DR 2010-07

FINAL ORDER

VAR 2010-06

FINAL ORDER
DR 2010-07, VAR 2010-06
EXHIBIT A

Detail from Figure 7-2 of the Transportation System Plan

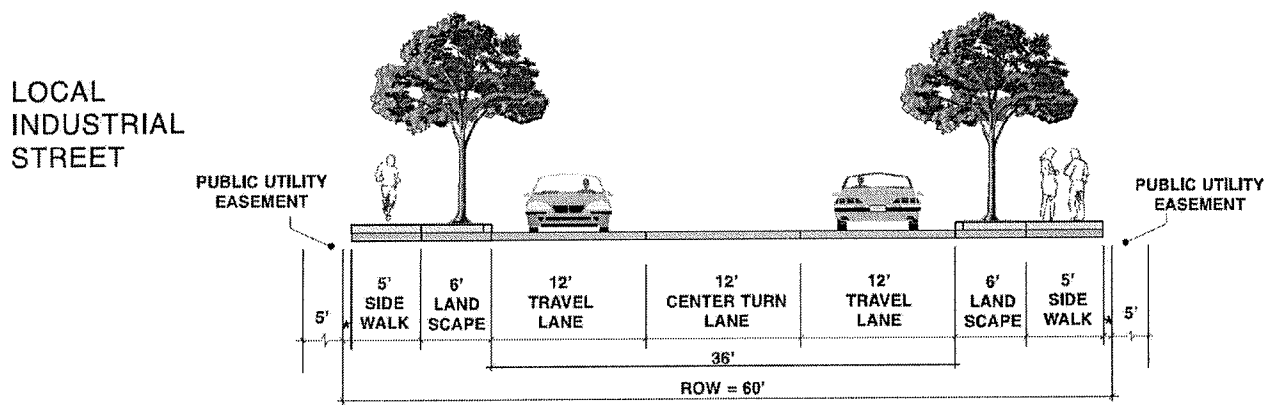
Findings: National Way and Pacific Highway 99E are the Boundary and the Connecting Streets for the subject parcel, as defined in WDO 1.102 and shown in Figure 6.12. National Way is classified as a local industrial street in the Transportation System Plan. The required cross-section is a 60 foot right-of-way, 36 foot improved driving surface (two 12 foot traffic lanes and a 12 foot center turn lane), 6 foot landscape strips and 5 foot sidewalks on both sides. The existing cross-section is a 90 foot right-of-way with 45 feet of improvements (2 foot curb and gutter on each side, and 41 feet improved driving surface), no planter strip and no sidewalks on either side. National Way is marked “No Parking” on both sides. The applicant proposes to construct a sidewalk adjacent to the building on National Way.

Conclusions: The right-of-way exceeds the dedication required by the Transportation System Plan. The applicant must provide the full street improvements required by the Transportation System Plan for National Way (a sidewalk along the full frontage), or obtain an Exception to Street Right-of-Way and Improvement Requirements, in accordance with Section 3.101.02.D.

DESIGN REVIEW SITE PLAN

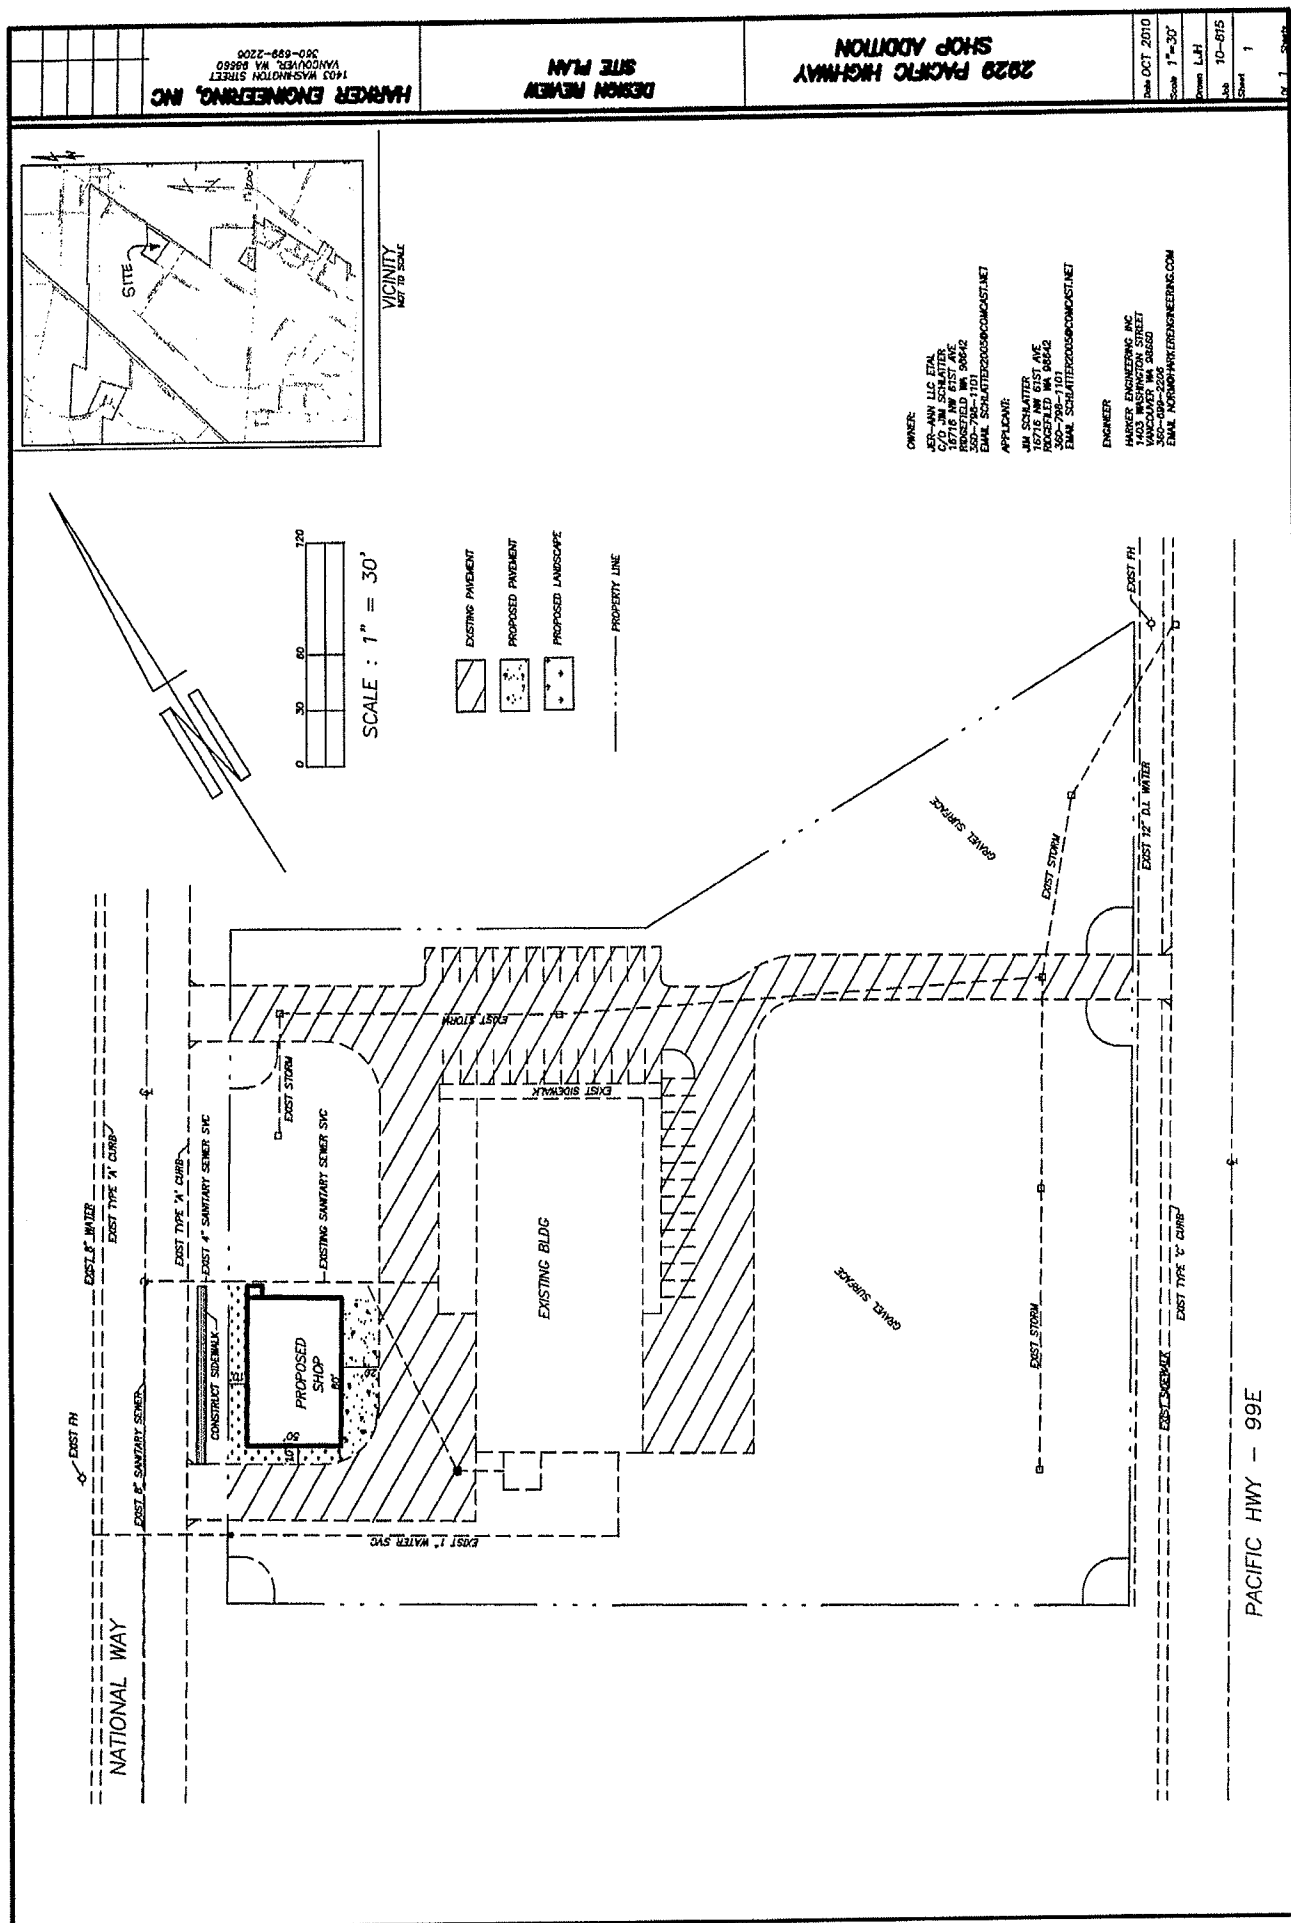
Forty parking spaces were required under Site Plan Review SPR 1986-01. The current application requires an additional 5 spaces. The site plan does not show accessible spaces

Findings: Table 3.1.4 sets the minimum dimensions for parking spaces and drive aisles. The site plan shows forty existing 90° parking spaces that scale at approximately 9 feet wide and 19 feet long. The drive aisles are shown as at least 32 feet wide. The site plan does not show additional off-street parking for the proposed development.

Findings: Section 3.105.02.H.5 provides that “Off-street parking and maneuvering areas shall have directional markings and signs to control vehicle movement.” The site plan does not show directional pavement markings.

Findings: Section 3.105.02.H.10 provides that “All uses required to provide 10 or more off street parking spaces shall provide a bicycle rack within 50 feet of the main entrance. The number of required rack spaces shall be one plus one per ten vehicle parking spaces, with a maximum of 20 rack spaces.” The proposed development requires 5 additional parking spaces. The site plan does not show bike spaces.

Findings: Section 3.106.03.A.1 requires street trees to be planted along National Way. The site plan does not show street trees.

Conclusions: The proposed development has not been shown to meet the requirements of ORS 447.233(2) (a) through (c). The property owner must provide at least 2 accessible parking spaces, including at least one van-accessible space.

Conclusions: The proposed development has not been shown to meet the requirements of Table 3.1.4 for the proposed development. The property owner must provide parking space and aisle dimensions that comply with Table 3.1.4 for the 5 new off-street parking spaces.

Conclusions: The proposed development does not meet the requirements of Section 3.105.02.H.5. The property owner must provide directional markings and signs in the off-street parking area to control vehicle movement.

Conclusions: The bicycle rack requirement is only for the proposed development. The property owner must provide one bicycle rack space, in accordance with Section 3.105.02.H.10.
